REQUEST FOR TENDER No. 20-062

Meadowood Community Centre Construction

**Addendum 4 (17 pages)
Issued: December 3, 2020**

ADDENDUM – 04

- TANK INSTALLATION:**
1. WHEN INSTALLING SEPTIC TANKS, A SPREADER BAR SLING IS REQUIRED TO KEEP PRESSURE OFF SIDES OF TANK. CABLES SHOULD NEVER BE PULLED UP AND OVER SIDES OF TANK, WITH NO SPREADER BAR, DAMAGE MAY OCCUR TO THE TANK, KEYWAY OR BOTH.

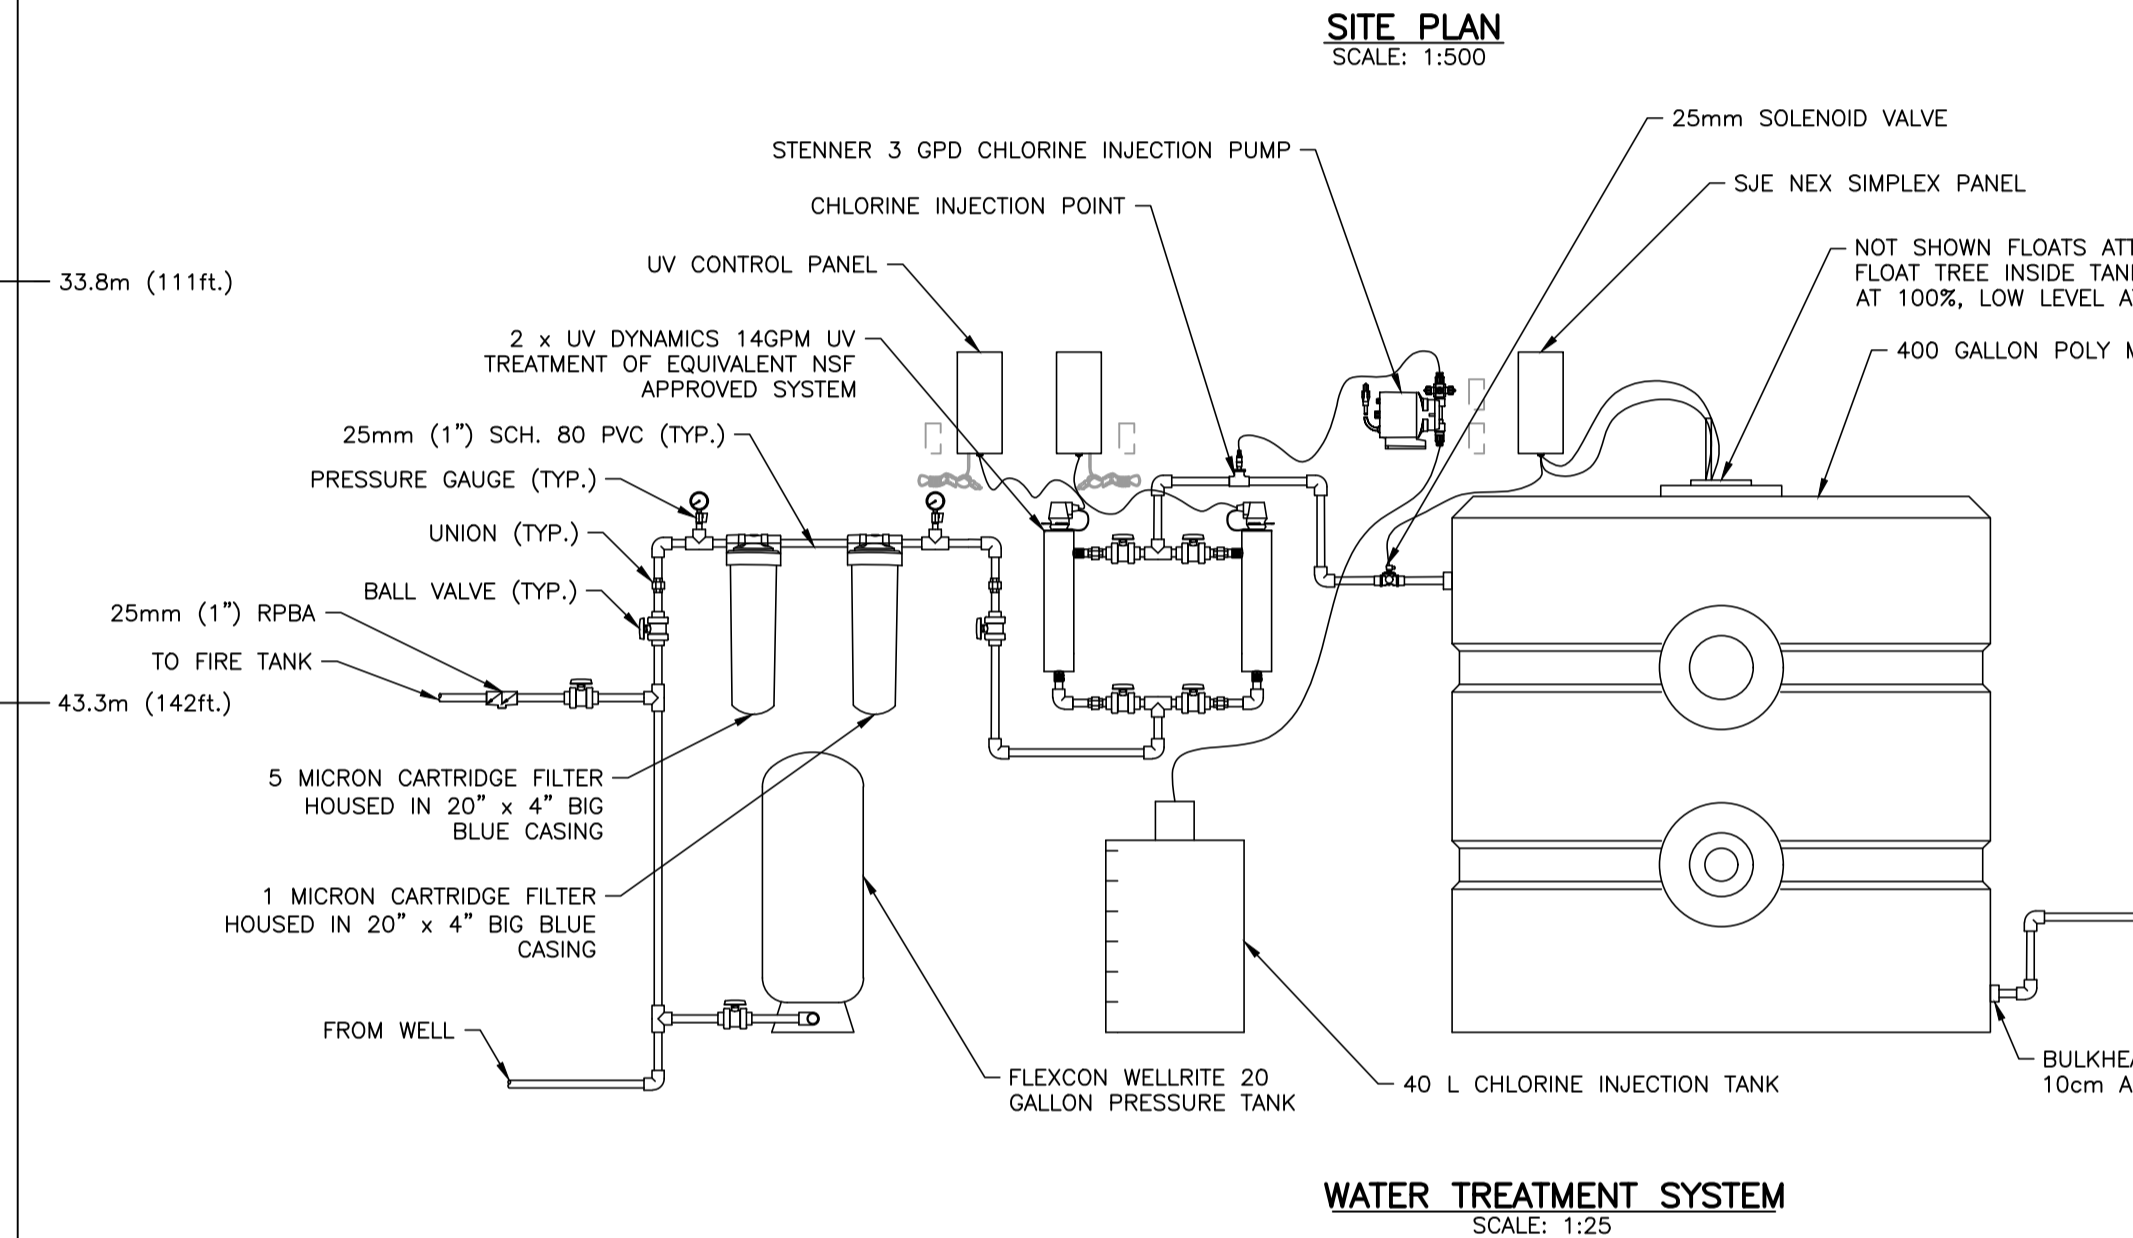
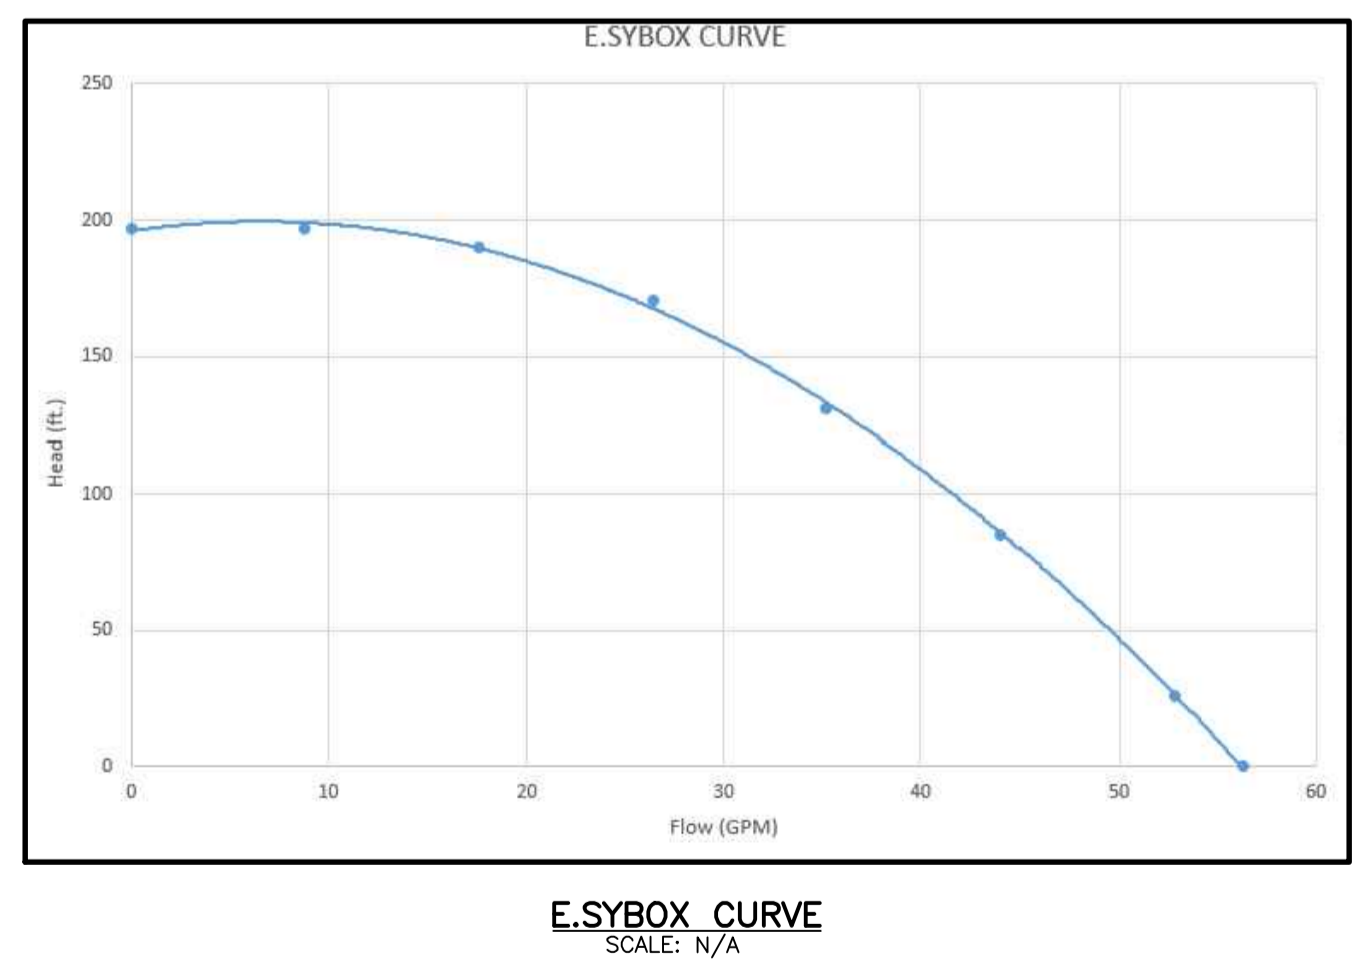
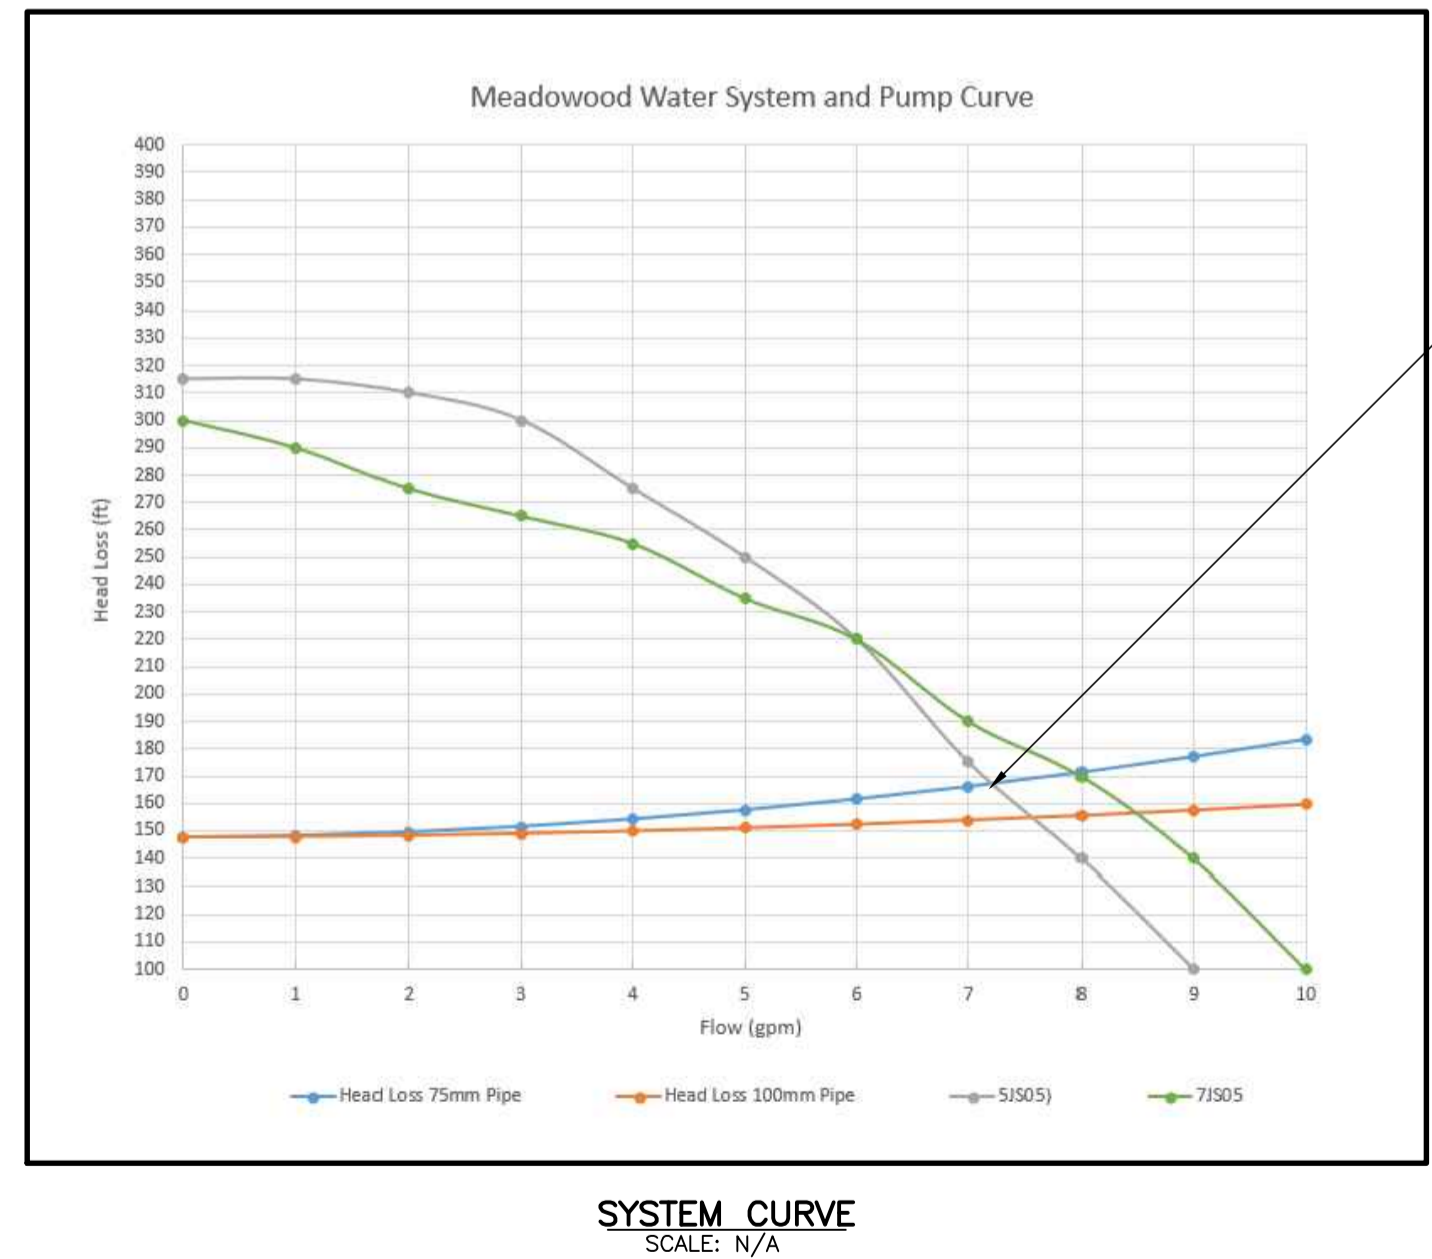
- .1 Updated MSR drawing C02 dated 2020.11.23 is attached.
- .2 The electrical duct can be installed in the common trench to the well head location

NO.	DATE	BY	REVISIONS	ENG
1	2020.12.01	C.S.	POINT OF ENTRY SYSTEM AND FIRE RETURN	X.X.

FOUNDATION PLAN - PLUMBING
1
M:01
1/4" = 1'-0"

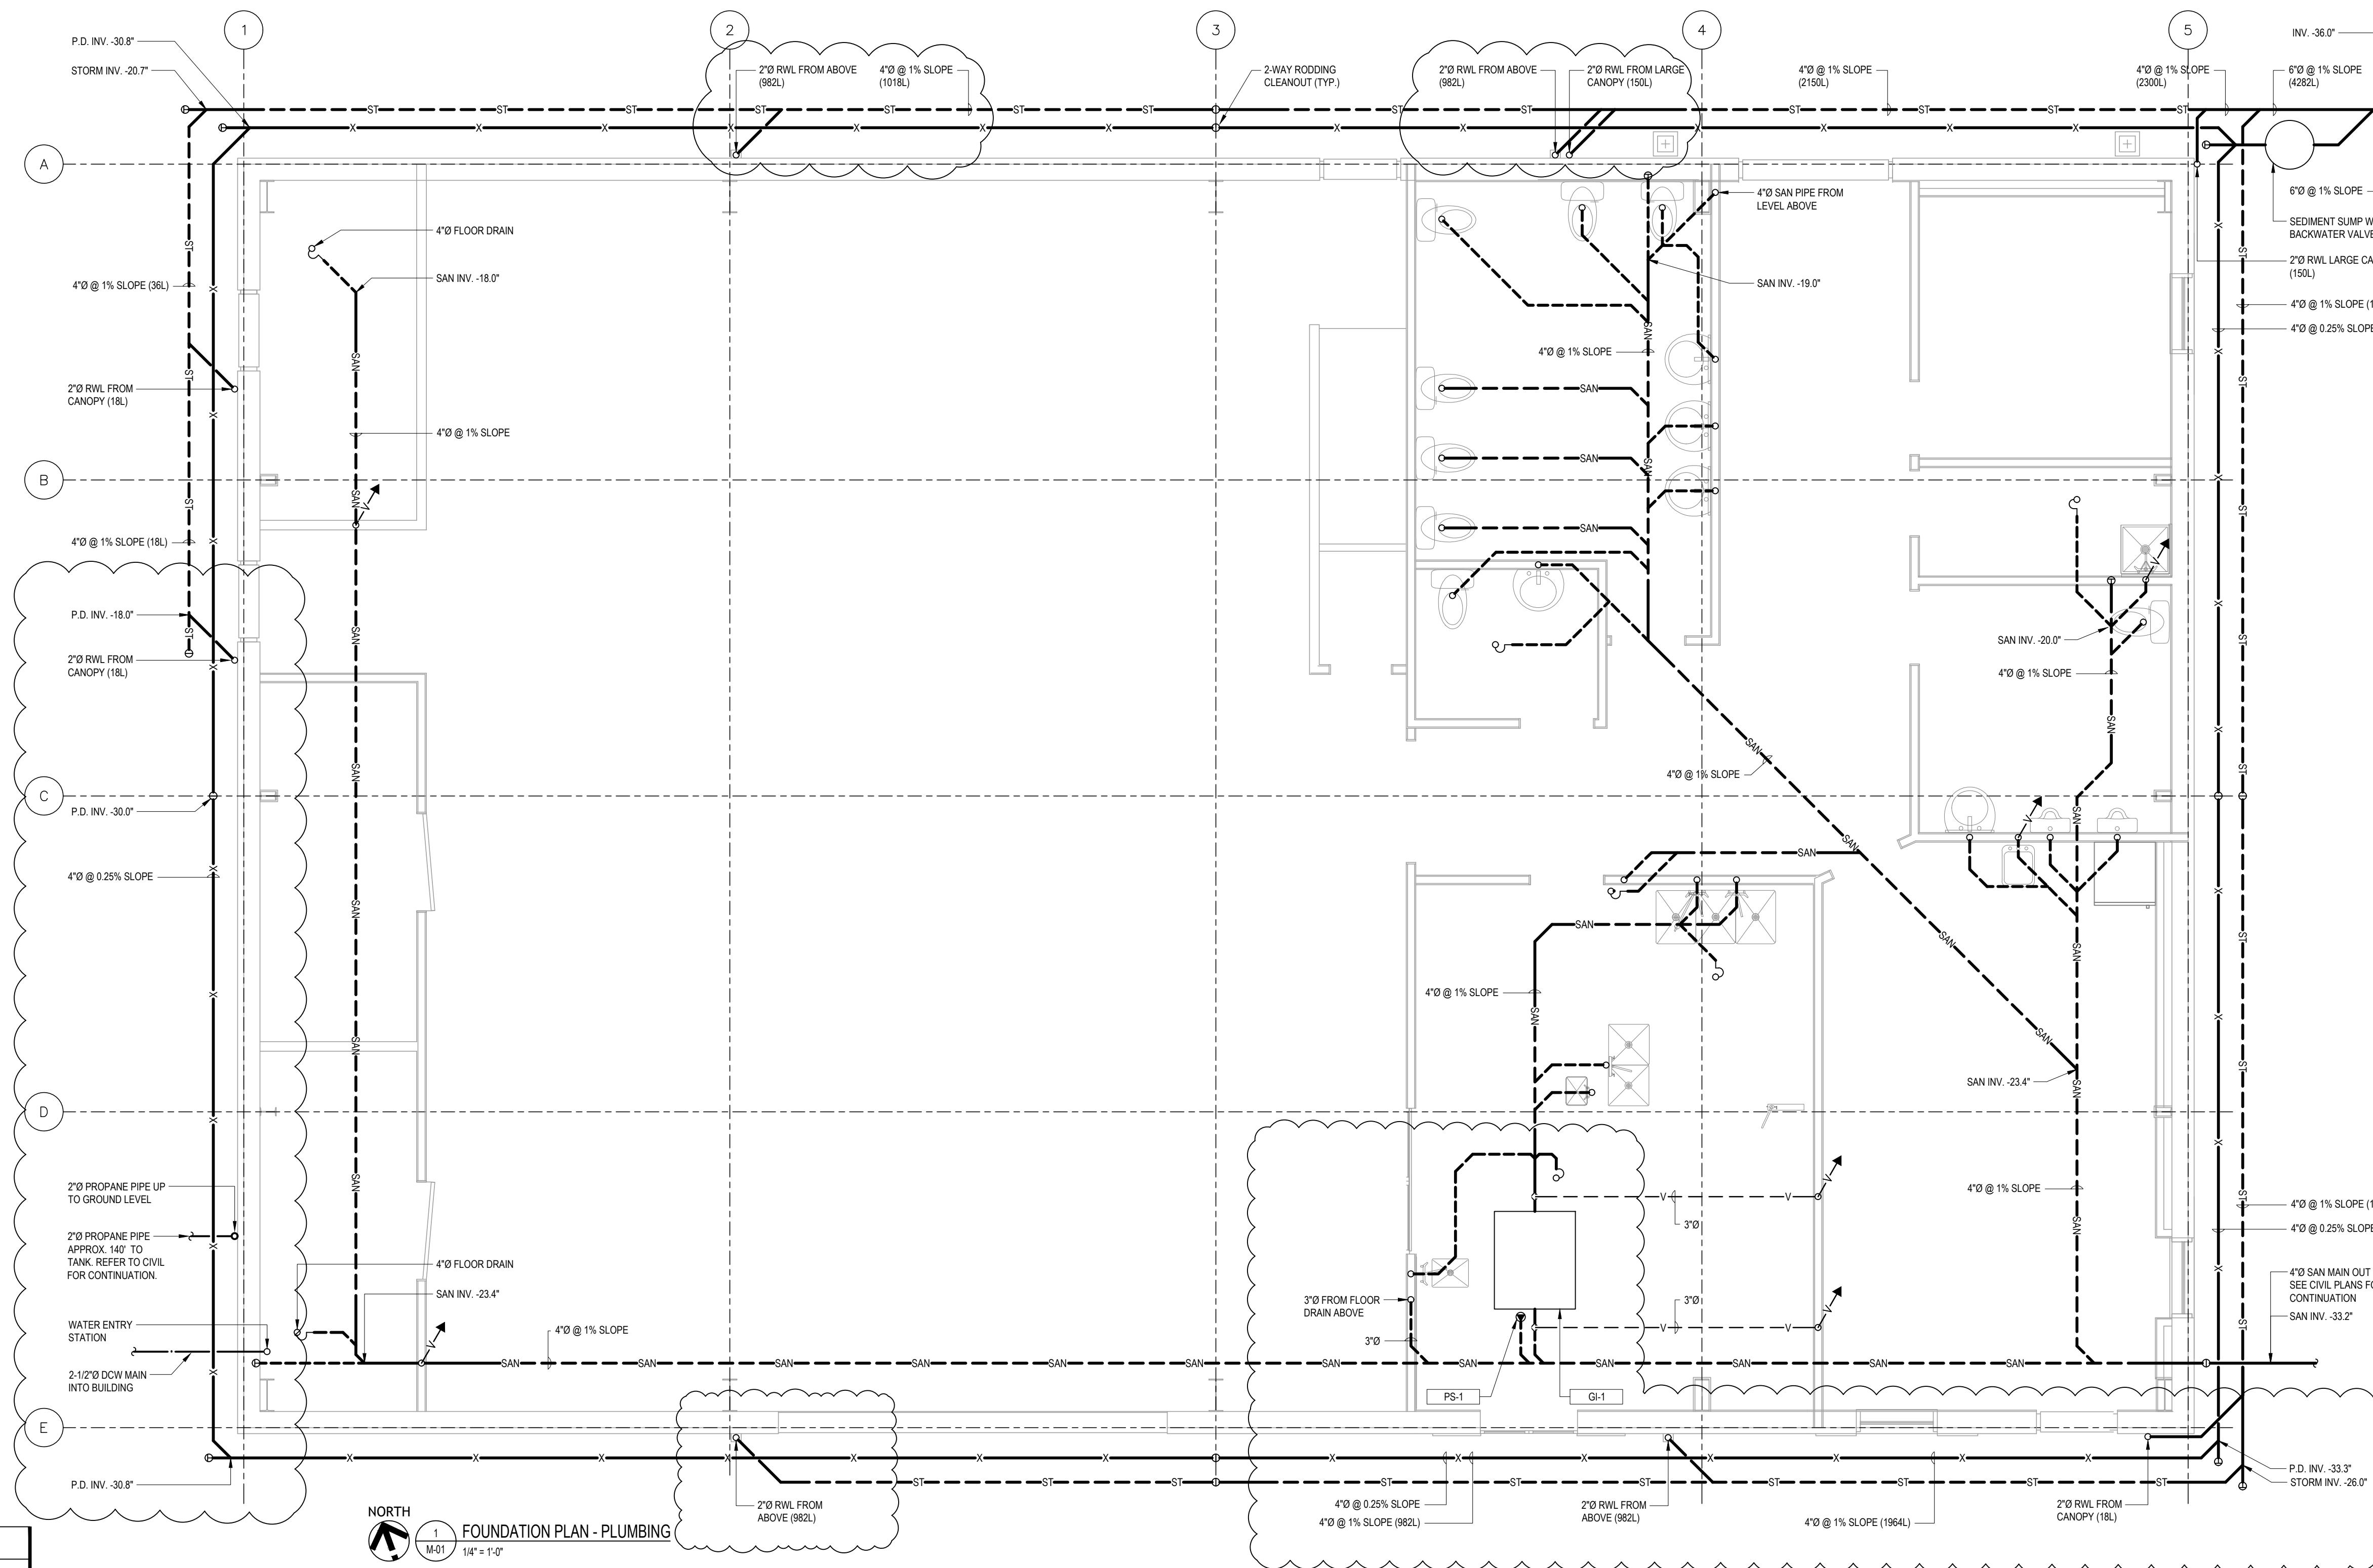
Refer to DRAWING M-1 (see attached)

| REVISE: | 1. | Revise the location of rainwater leaders and associated storm piping. |
| | 2. | Moved drawing note to coordinate with architectural plans for location and size of RWL. |
| ADD: | 1. | Add sanitary piping from Bev. Sink to kitchen sanitary main. |
| | 2. | Add piping from mezzanine mechanical floor drain from level above to sanitary main. |
